Addendum #1

Date: 1-12-11

Reference: Kentwood Manor Area – Drainage, Street, Water & Sewer Improvements

Subject: Addendum #1

MAP No. 168-840, 170-840 SHEET 49 OF 50
 SECT. No. _____
 DR. R.L. CK. R.G. JOB No. 08-5003

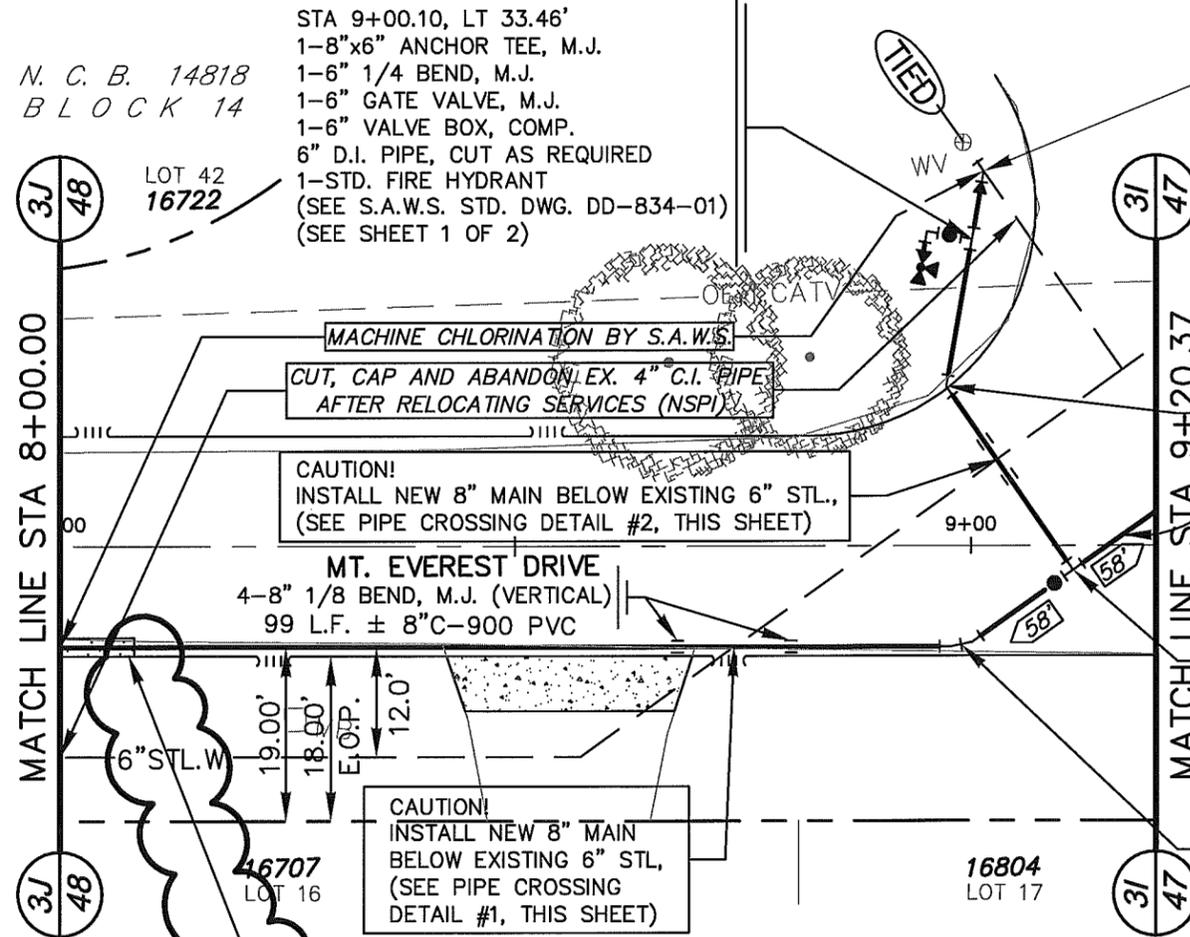
- 9) SAWS Water Plan sheet #49 has 8' of 24" carrier pipe at or near station 8+00, see change 8. There is a total of 18' of carrier pipe at this location, split on two sheets.
- 10) SAWS Sewer Plan Cover sheet and Sheet #3 have been updated to include added sheets (item #11) corrected quantities.
- 11) The project is located within the Edwards Aquifer Recharge Zone, an SCS has been submitted to TCEQ and the following plan sheets have been added to the plan set in order to achieve TCEQ approval. There are no additional materials from the original bid set, this is just additional information on the same design. The additional sheets are as follows:
 - Sheets: 5G, 5H, 5I
 - Sheets: 6I, 6J, 6K, 6L,
 - Sheets: 7G, 7H, 7I,
 - Sheets: 8D
 - Sheets: 9G, 9H, 9I
 - Sheets: 10D
 - Sheets: 11G, 11H
 - Sheets: 12A-G

MAP No. 108-840, 170-840 SHEET 48
SECT. No. _____
DR. R.L. CK. R.G. JOB No. 08-5003 OF 50

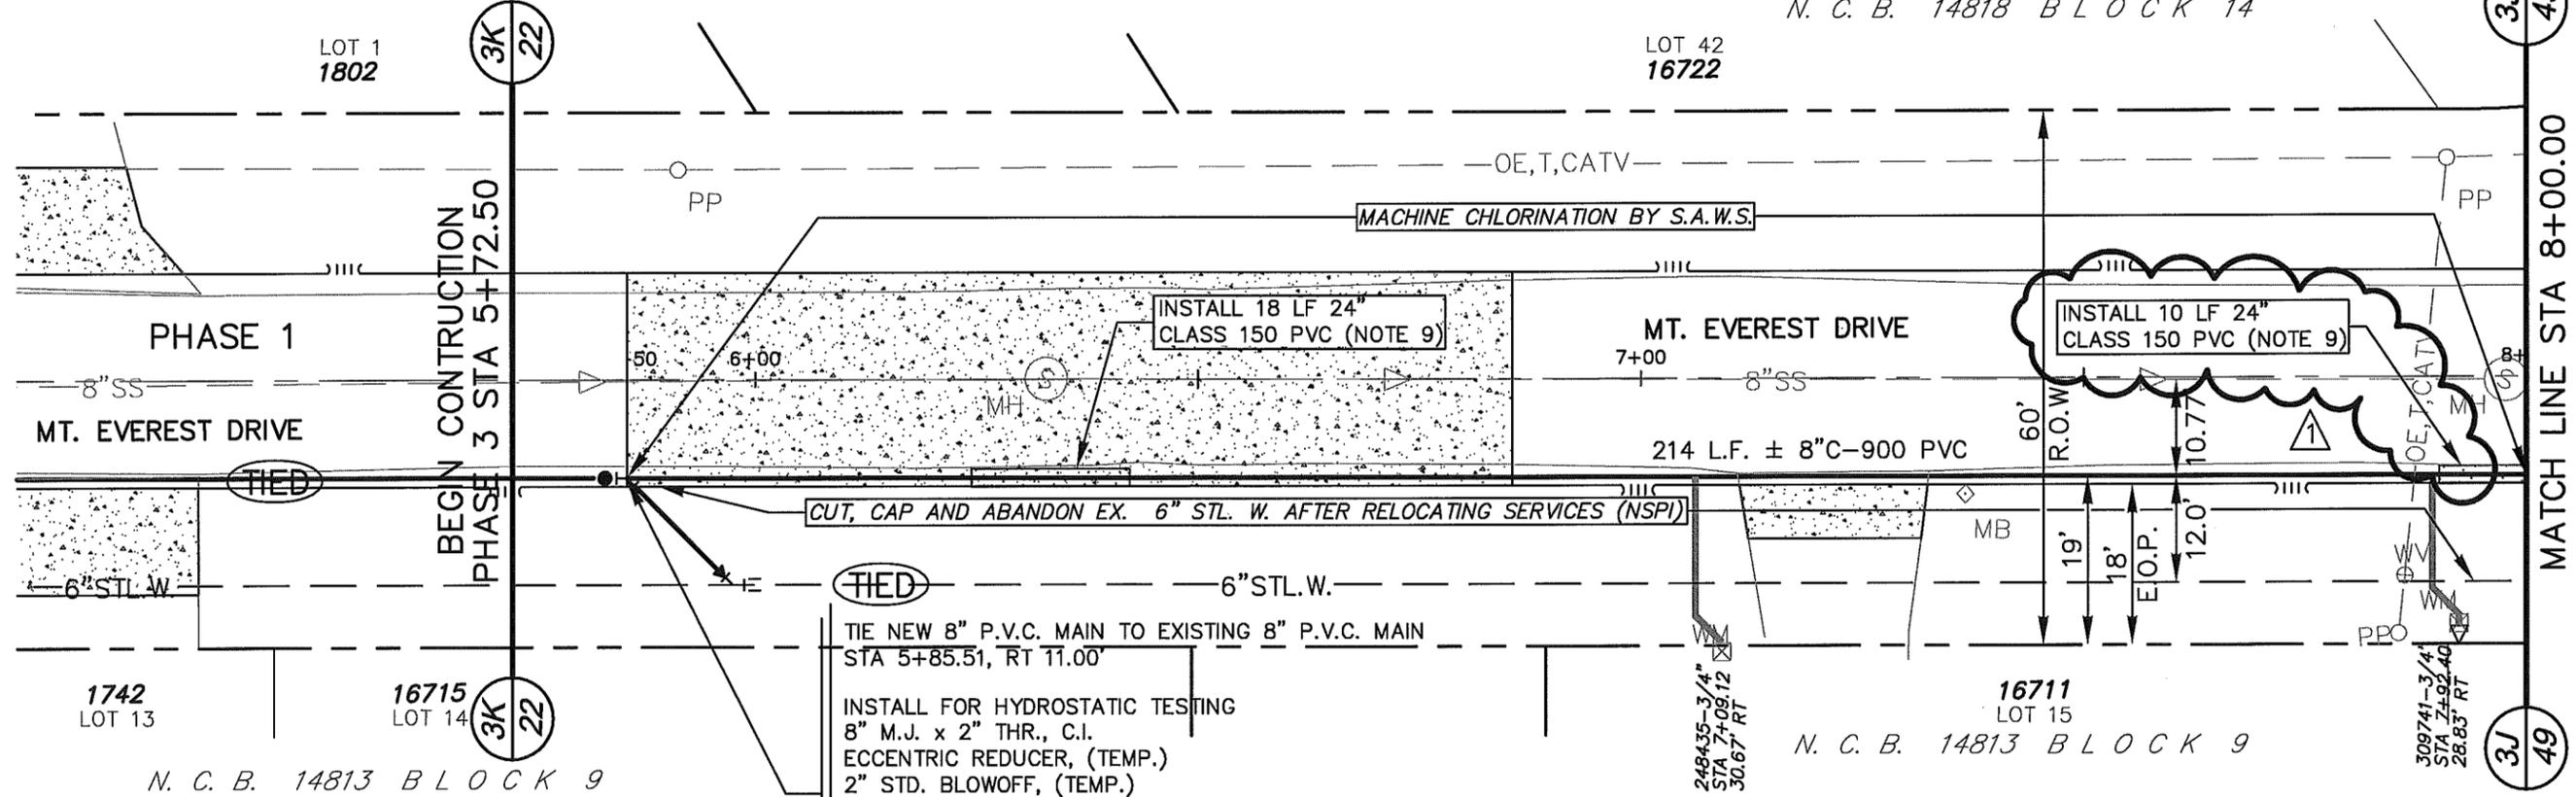
- 7) SAWS Water Plan sheet #46 has been modified placing the 8” water line over the storm water line and eliminating the 24” carrier pipe.
- 8) SAWS Water Plan sheet #48 has only 10’ of 24” carrier pipe at or near station 8+00, see change 9.

KENTWOOD MANOR BOND PROJECT
 STORM DRAIN LINE "G" - PHASE 3
 PLAN and PROFILE
 STA. 10+00.00 TO STA. 14+00.00

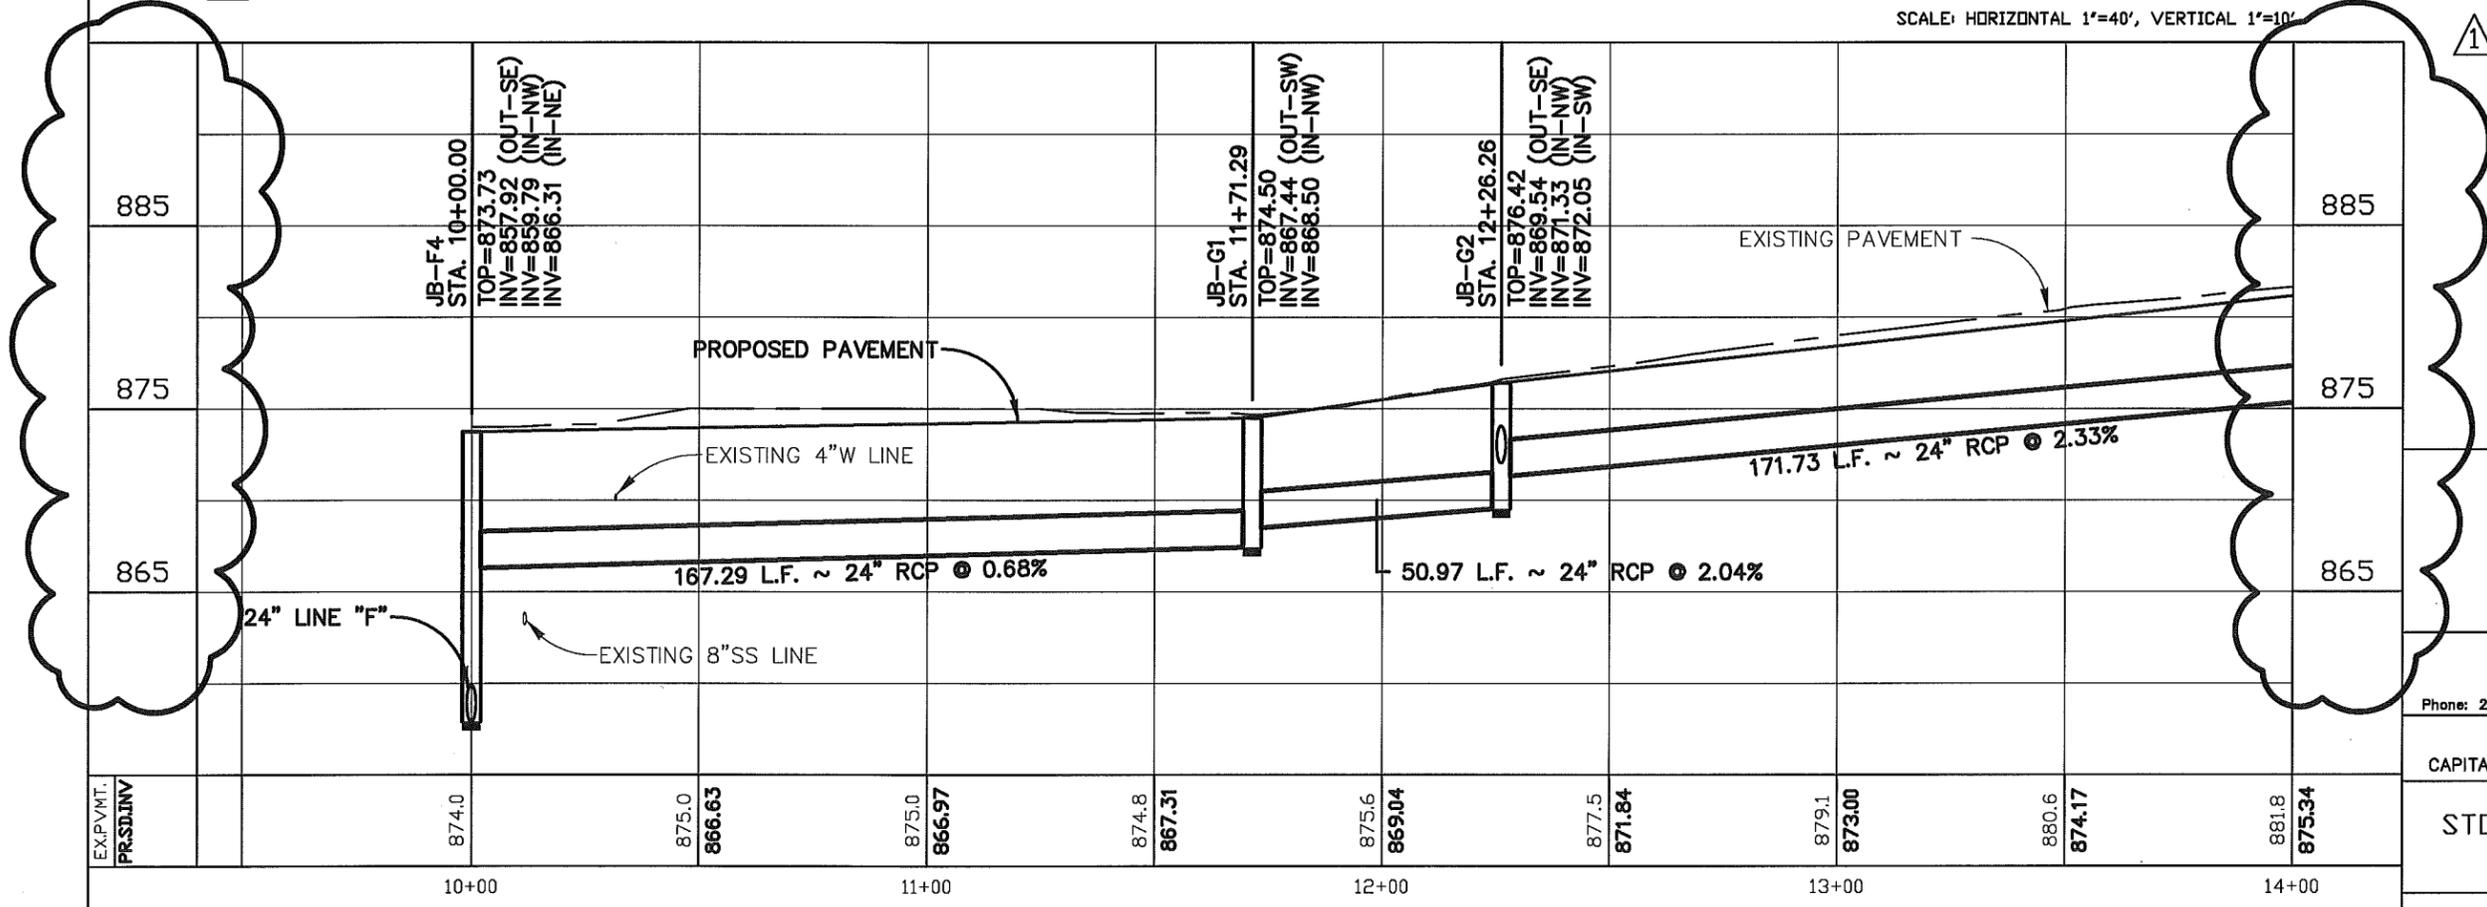
- 5) Plan sheet #94 has been modified to indicate the correct elevations in the right and left side bars.
- 6) SAWS Water Plan sheet #3 has been modified to match the changes with the Unit Pricing Form #025.
